EASTERN REGIONAL POWER COMMITTEE

MINUTES OF 19th PROTECTION SUB-COMMITTEE MEETING HELD AT ERPC, KOLKATA ON 16.05.2014 (FRIDAY) AT 11:00 HOURS

SYSTEM DISTURBANCE AT BTSPS'B ON 13.04.14

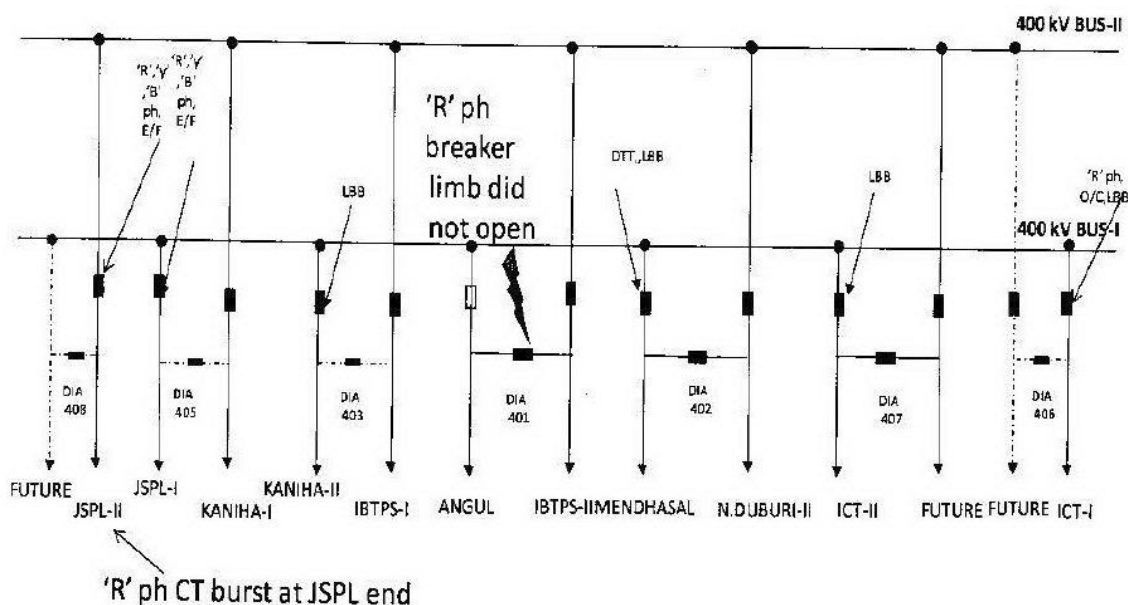
DVC representative informed that, when fault occurred in 220kV Bokaro-Jamshedpur-I, all REL-670 relays installed in DVC system remained inoperative. Further investigation revealed that status LED of each relay was blinking, indicating fault in relay measurement circuit. As a result REL-670 relays at Bokaro-B and at Jamshedpur failed to pick up on occurrence of the fault. Ultimately from Jamshedpur side the fault got cleared by tripping of 220kV Jindal-Jamshedppur line from Jindal end. From Bokaro-B side the fault got cleared by opening of all 220kV lines connected to Bokaro (except Jamshedpur) from respective remote ends. As a result Bokaro bus became dead and the running units tripped.

DVC subsequently ascertained from the OEM of these relays, M/S ABB, that firmware of REL-670 relays required upgradation. At present, the same has been upgraded.
